SUBJECT: SUPPLEMENT IN RESPONSE TO DATA ADEQUACY
COMMENTS ON THE APPLICATION FOR CERTIFICATION FOR
THE WALNUT CREEK ENERGY PARK (05-AFC-02)

In Response to Data Adequacy Review

Walnut Creek Energy Park

(05-AFC-02)

SCE Area Summary

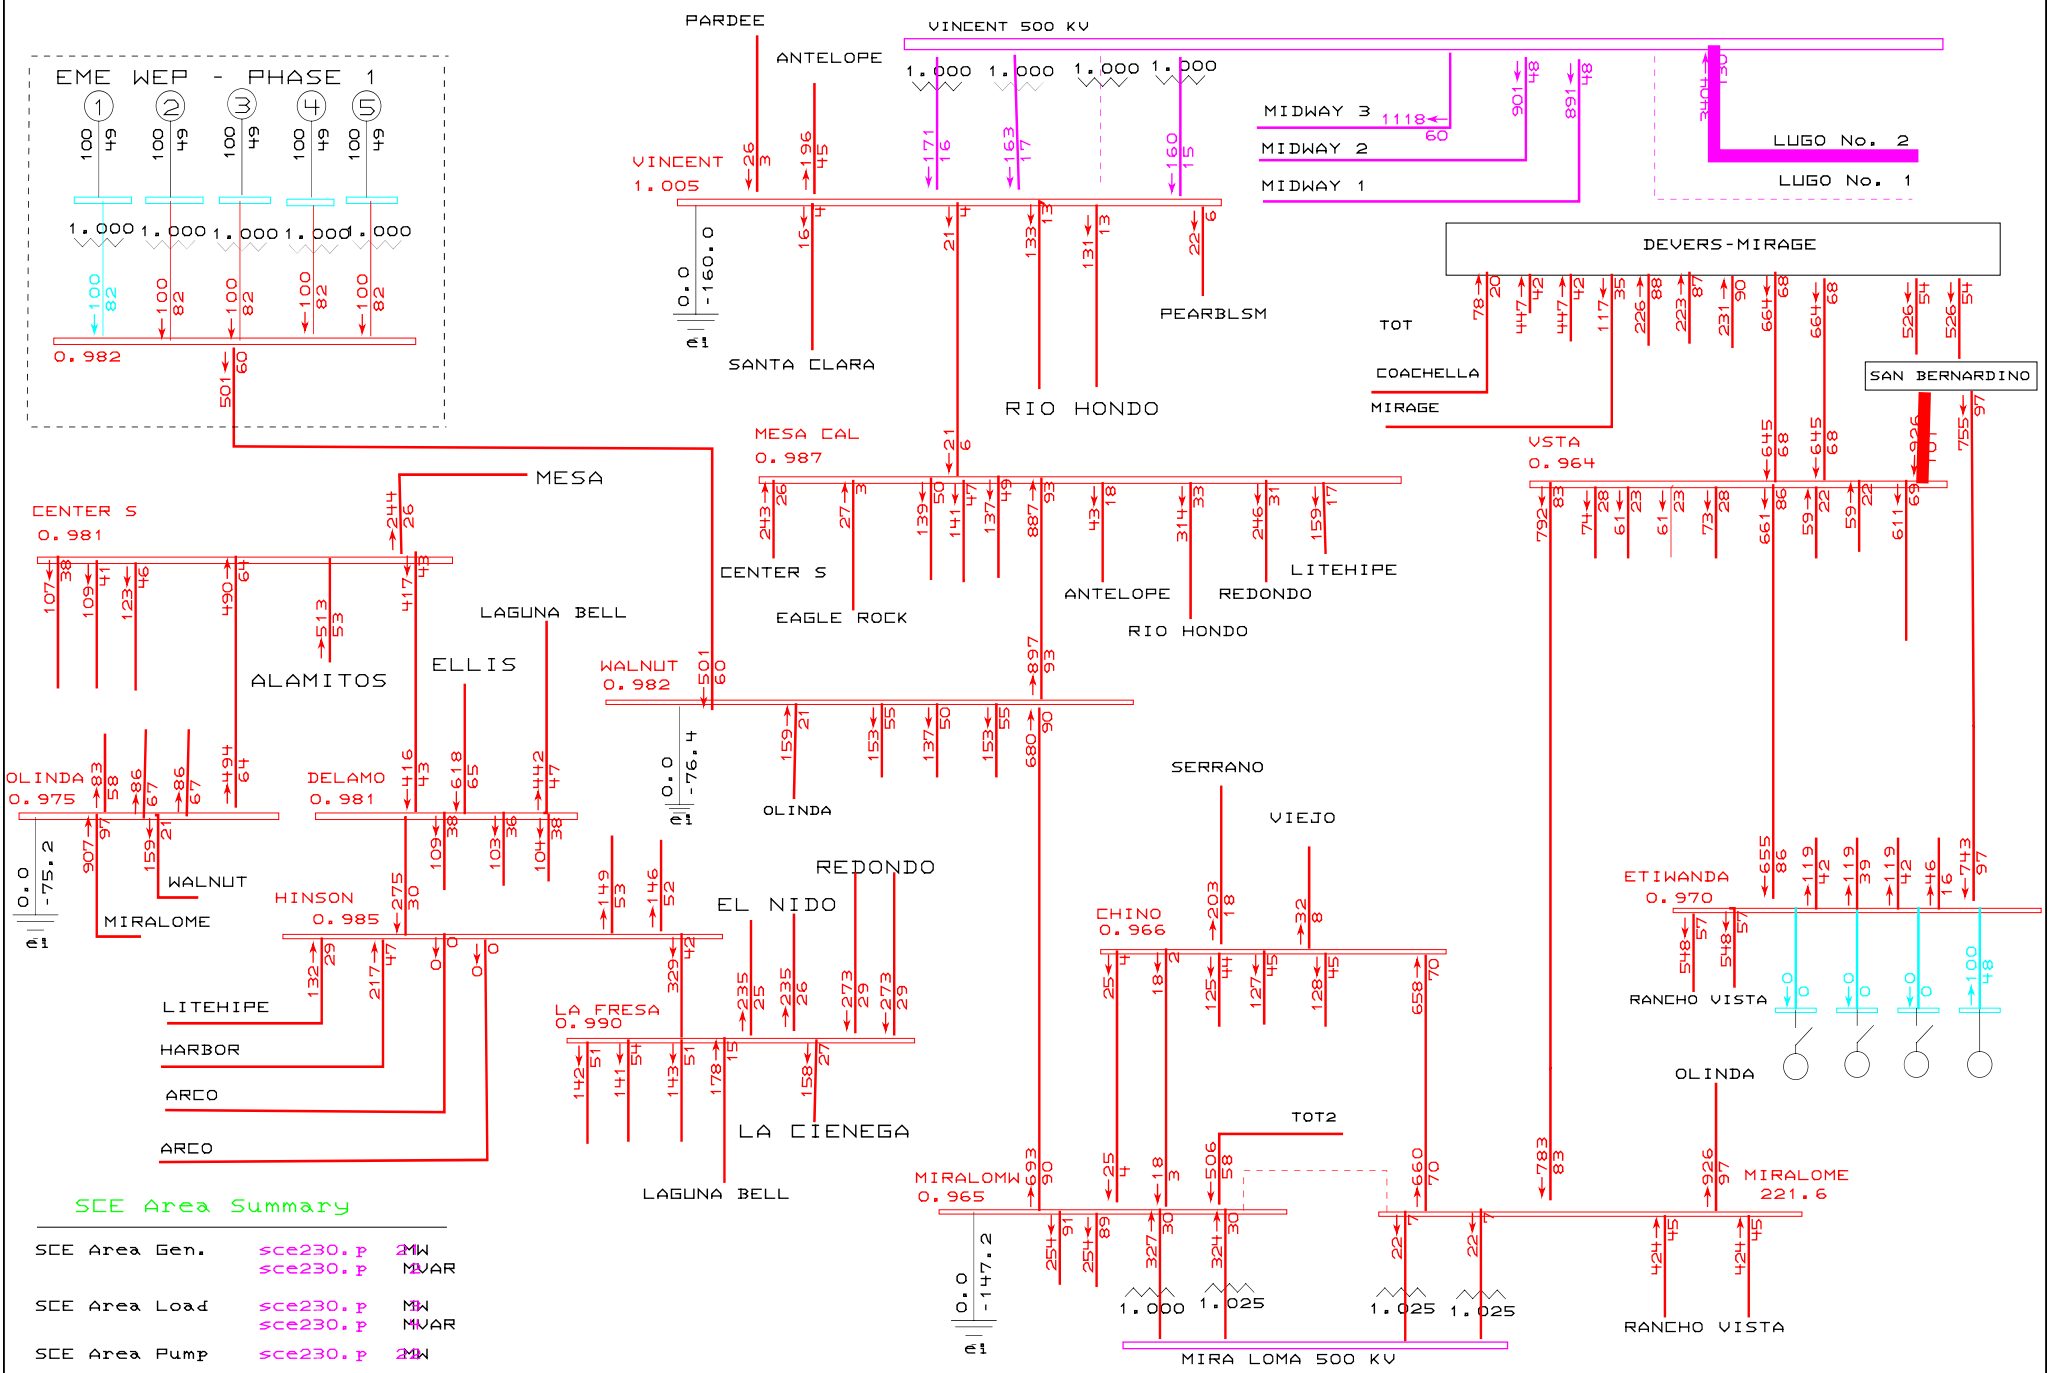
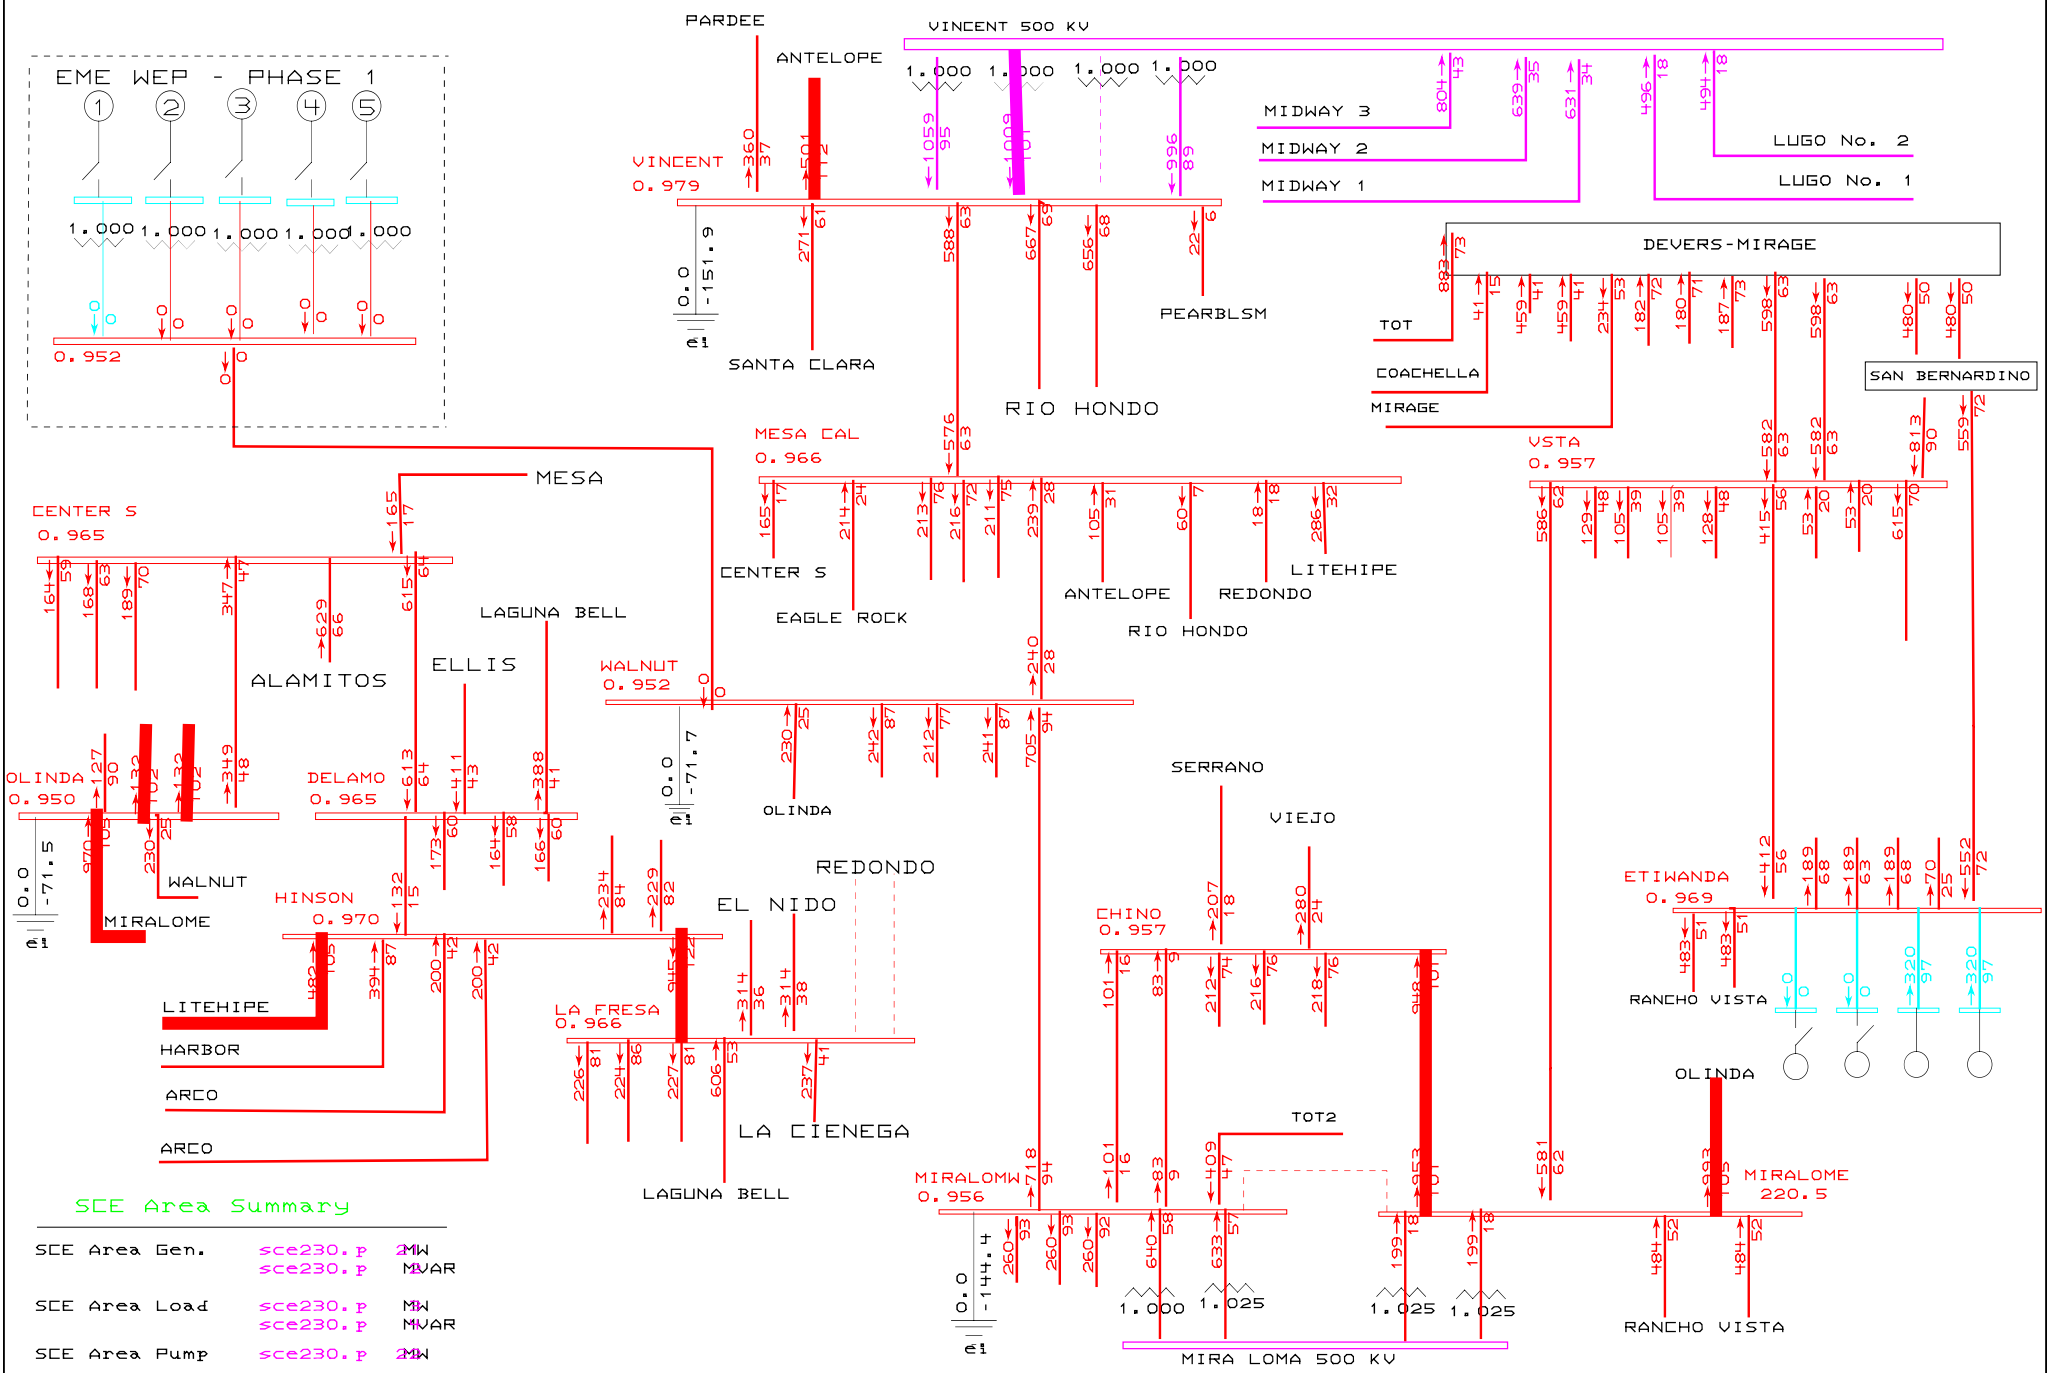
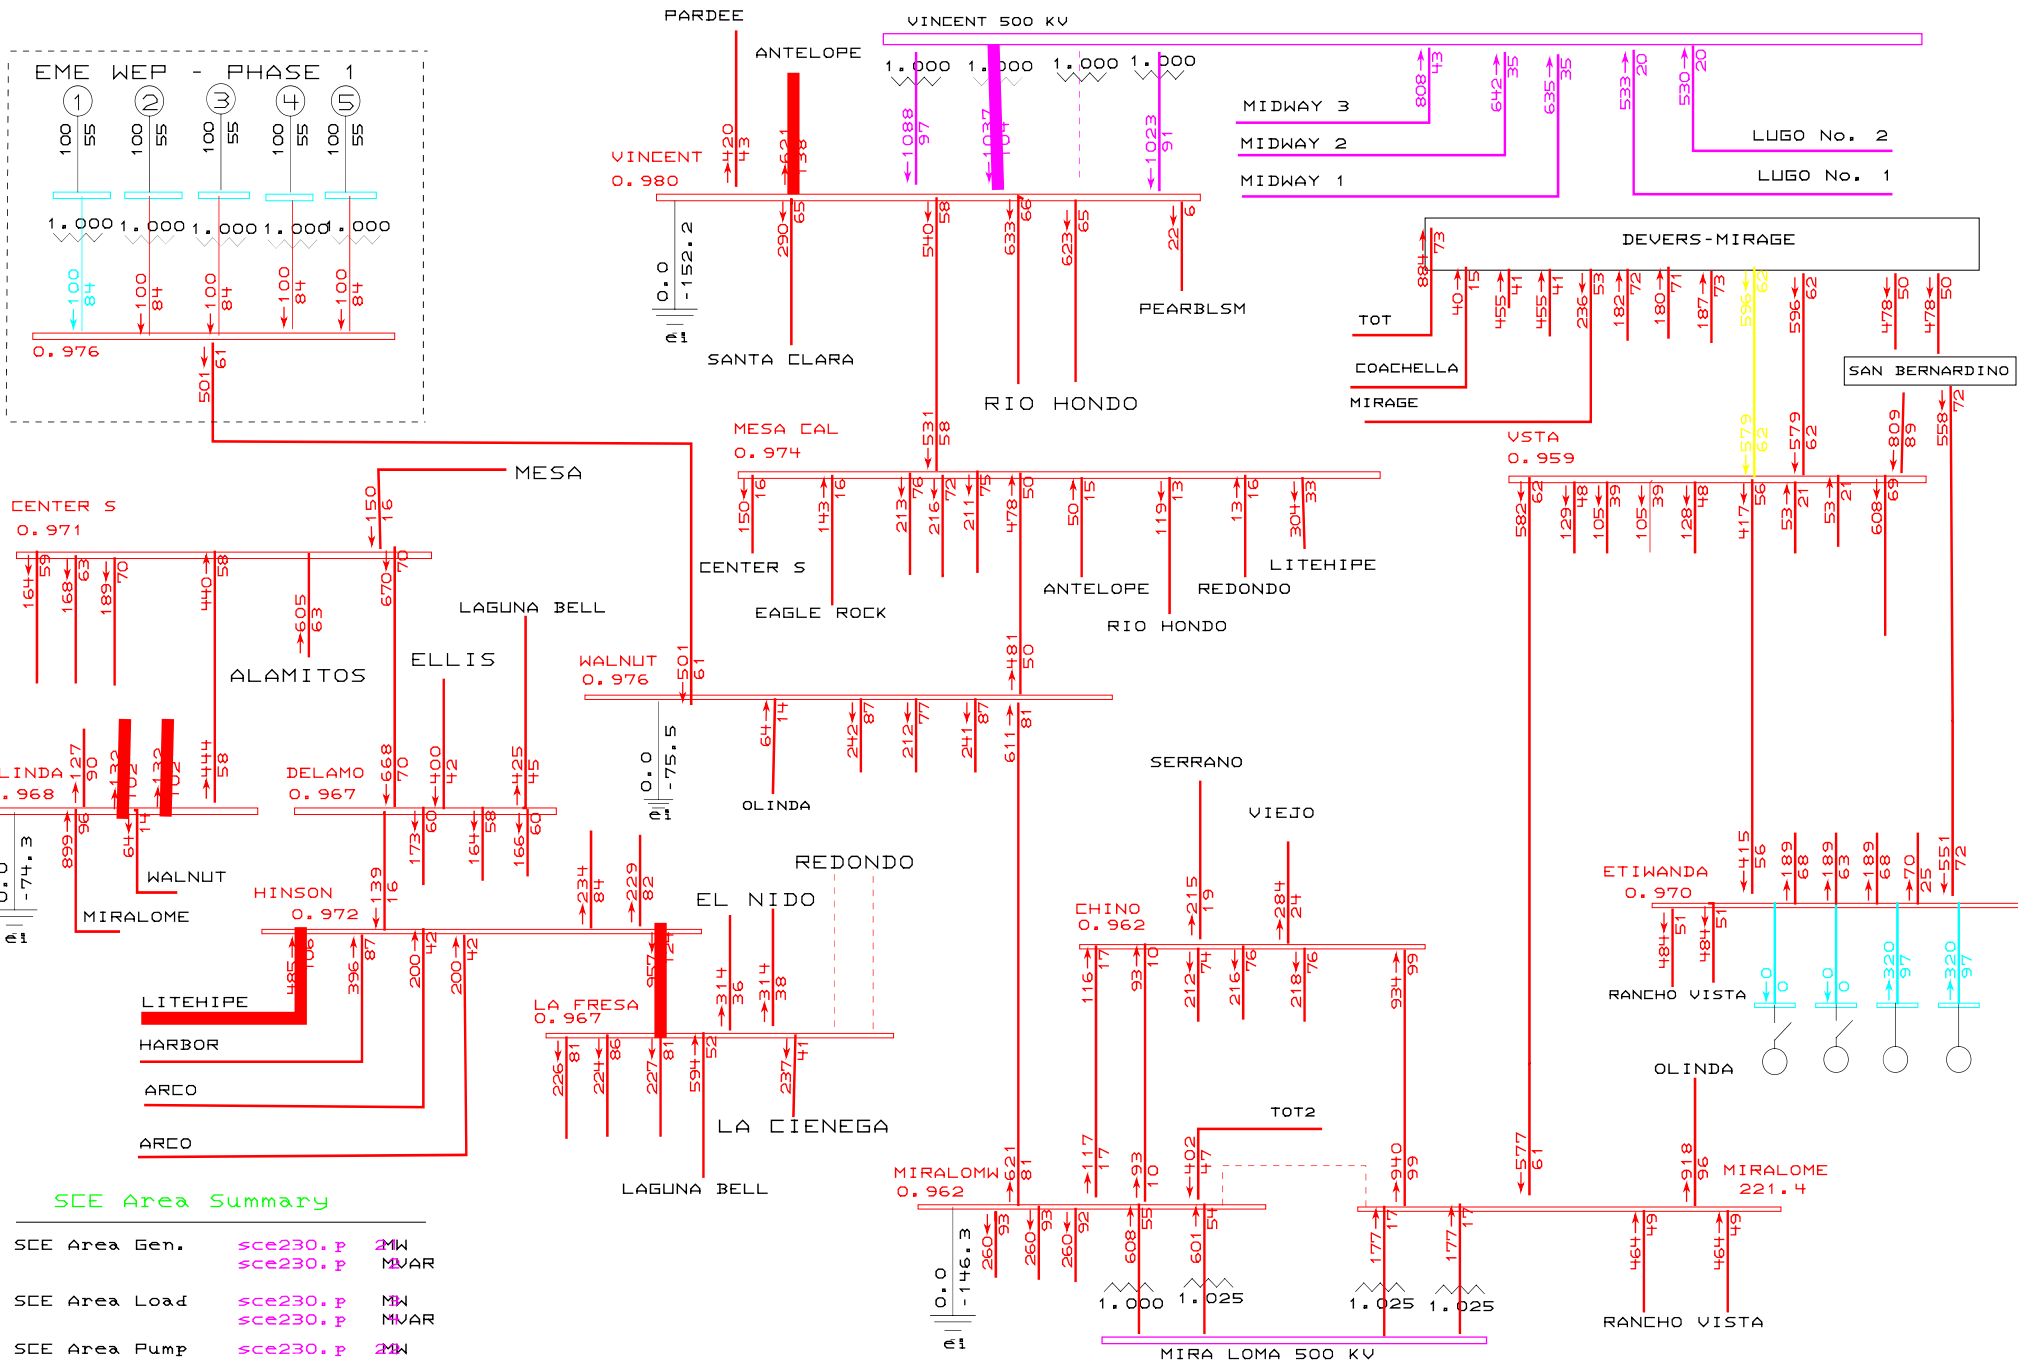
Provide power flow diagrams (MVA, % loading & P. U. voltage) for all N-1 and N-2 contingencies where overloads or voltage violations appear.

Response – Power flow diagrams for cases for which the WCEP would aggravate existing transmission system overloads are attached.
